# CITY OF KELOWNA

## MEMORANDUM

**DATE:** November 28, 2005  
**TO:** City Manager  
**FROM:** Planning & Corporate Services Department  
**APPLICATION NO.:** OCP04-0018 & Z04-0075

**PURPOSE:** To amend the Official Community Plan Future Land Use Map to reflect the proposed refined land uses in the concurrent rezoning application;

**A.3: Airborne Particle and Visual Screen**

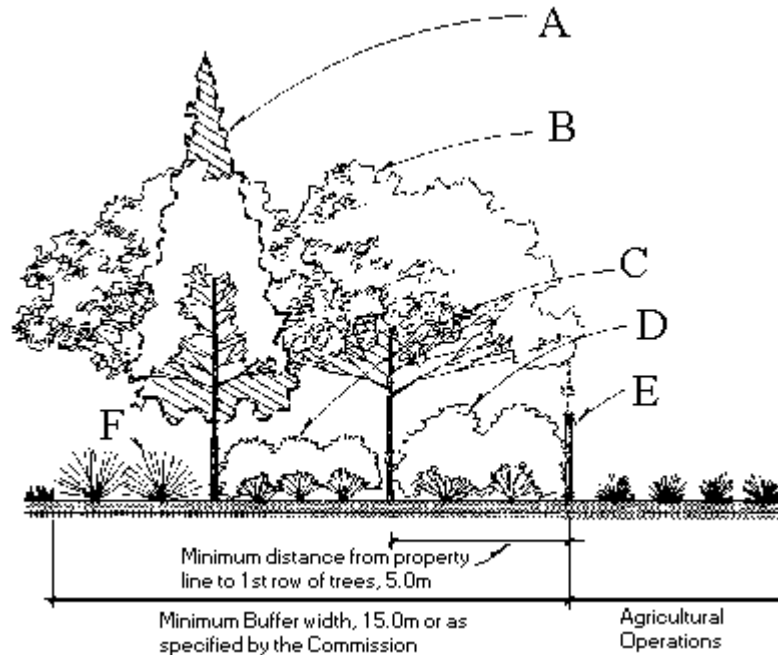
- It should be registered on title that this application is directly across from agricultural land which will be subject to noise, odour, dust, traffic and agricultural practices.
- The buffering standards that the committee recommends should be above and beyond the regular standards set by the City of Kelowna. The AAC strongly recommends that the A3 annual buffering (see attached specifications) be implemented.

- A. Yearly Screen - Minimum double row deciduous/coniferous trees. (continuous as shown) See Schedules B.2, C.1 & C.3
- B. Summer Screen - Minimum double row deciduous trees. (continuous) See Schedules B.1, C.1. Underplant and Fence as shown.
- C. Minimum triple row trespass inhibiting shrubs. (continuous) See Schedules B.5 & C.5
- D. Minimum double row screening shrubs. (continuous) See Schedules B.6, C.6a & C.6b
- E. Fence as per Schedule D. of Fencing Specifications
